High Desert Power Project

(97-AFC-1C)

**Amendment Petition
for
Alternative Water Supplies to Address
Drought-Related Reliability Impacts**

April 23, 2014

FIGURE 1
LOCATION OF PROPOSED PIPELINE SYSTEM

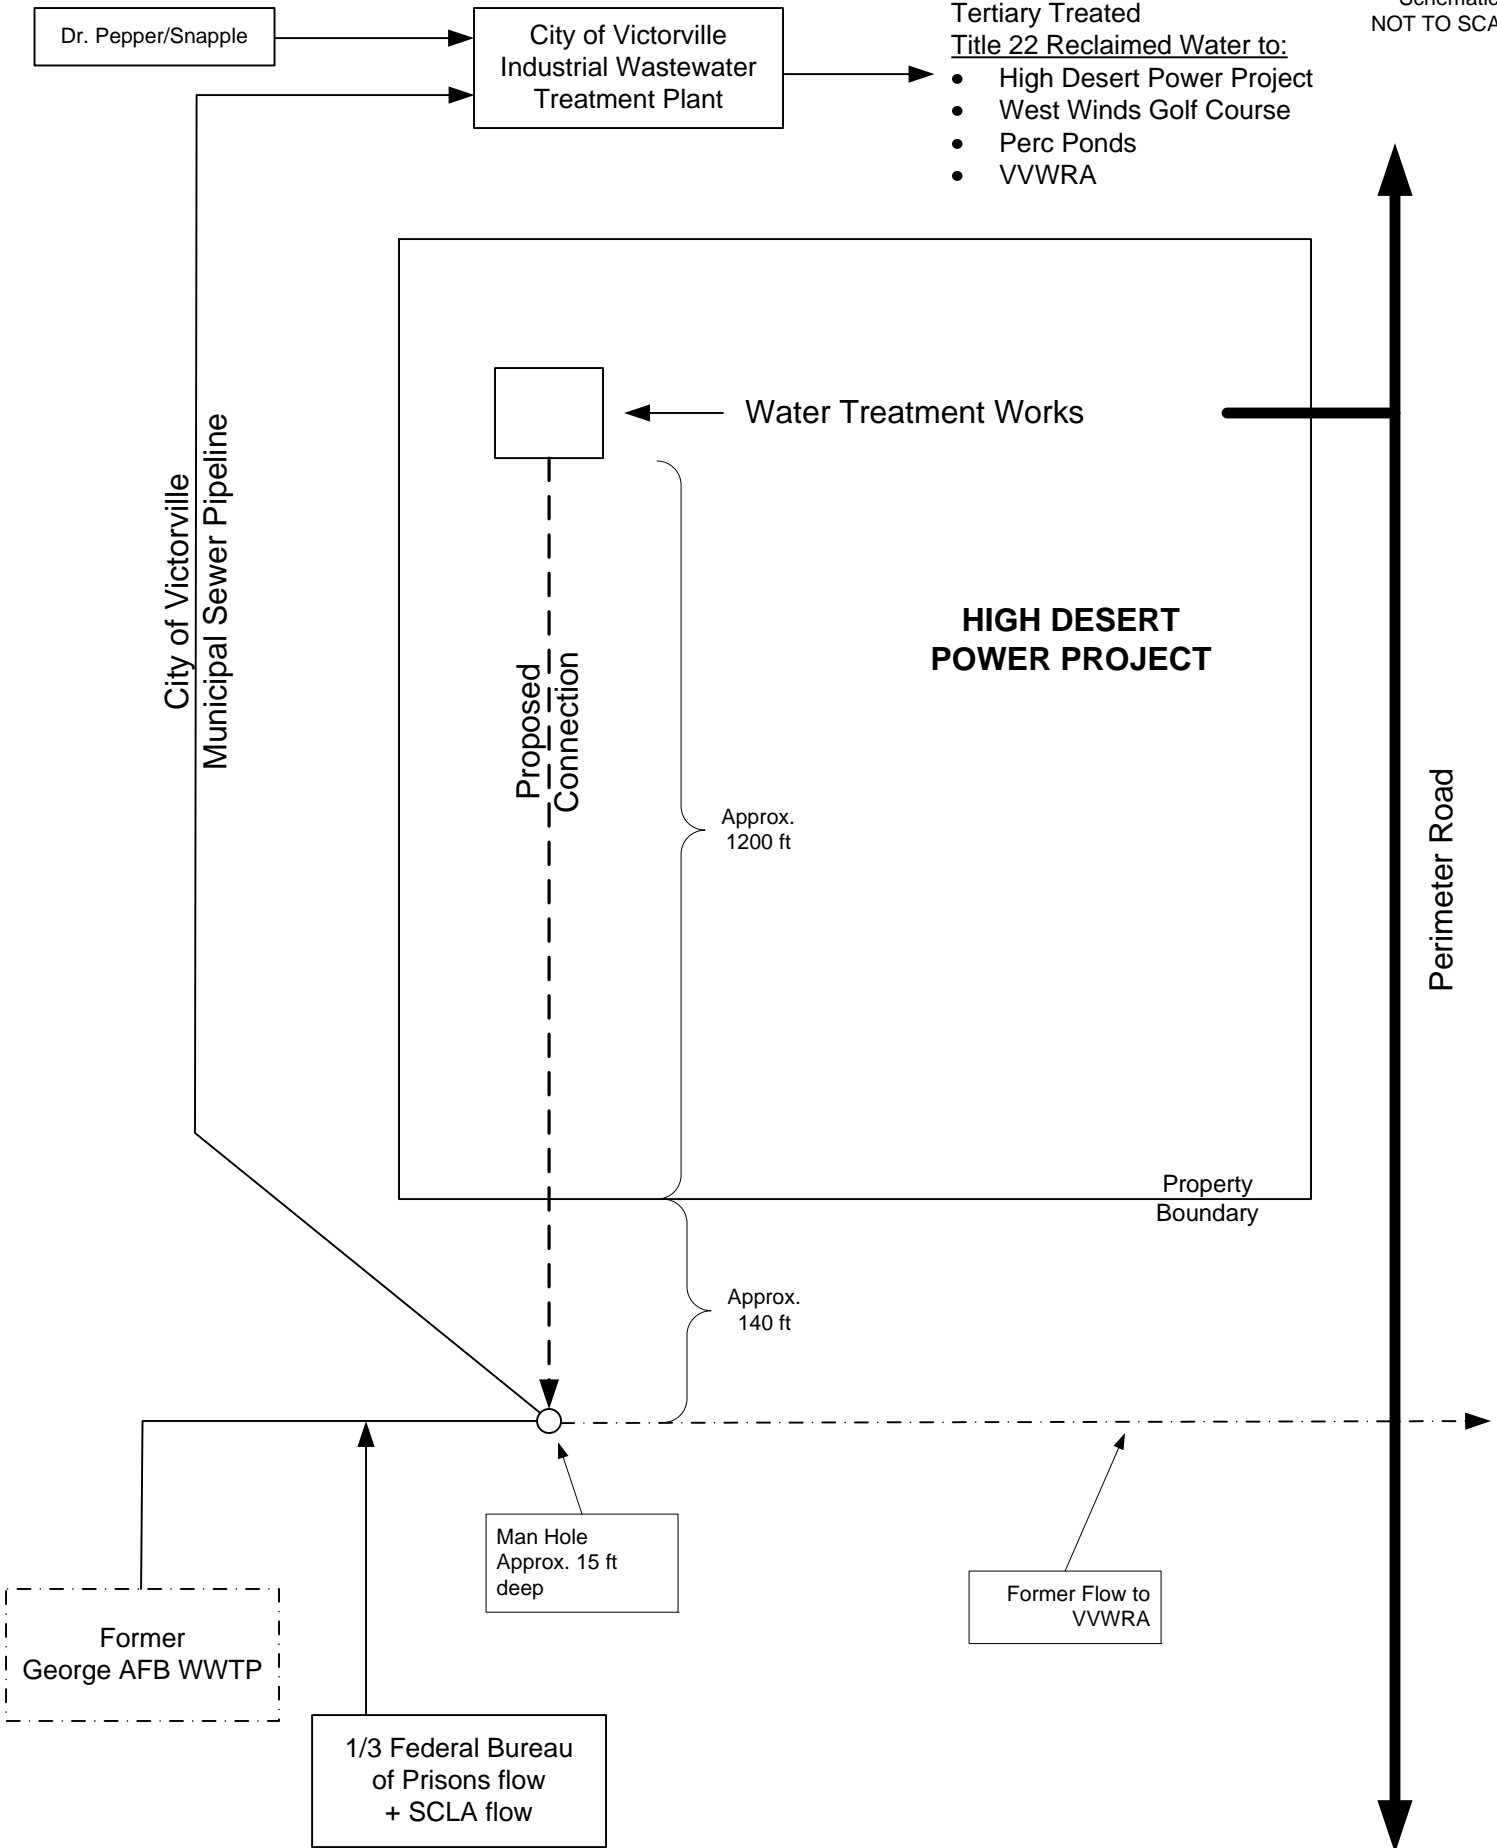
The only new infrastructure required for such discharges will be a pipeline system of approximately 1,340 feet to connect the project to the existing City of Victorville sewer system. The discharge pipeline will connect with the City of Victorville’s existing sewer pipeline located approximately 140 feet south of the HDPP site boundary, and connect with equipment in the northwest corner of the plant property approximately 1,200 feet north of the site boundary. (*See, Figure 1.*) Either an above-ground or below-ground

pipeline will pass through areas that have been paved or laid with gravel while on HDPP property. Areas offsite consist of previously graded, unvegetated landscape dirt located on Southern California Logistics Airport property. Equipment associated with the discharge pipeline system will potentially include isolation valves, analytical equipment, pumps, and metering devices. The discharged backwash streams will flow by gravity to the City IWWTP.
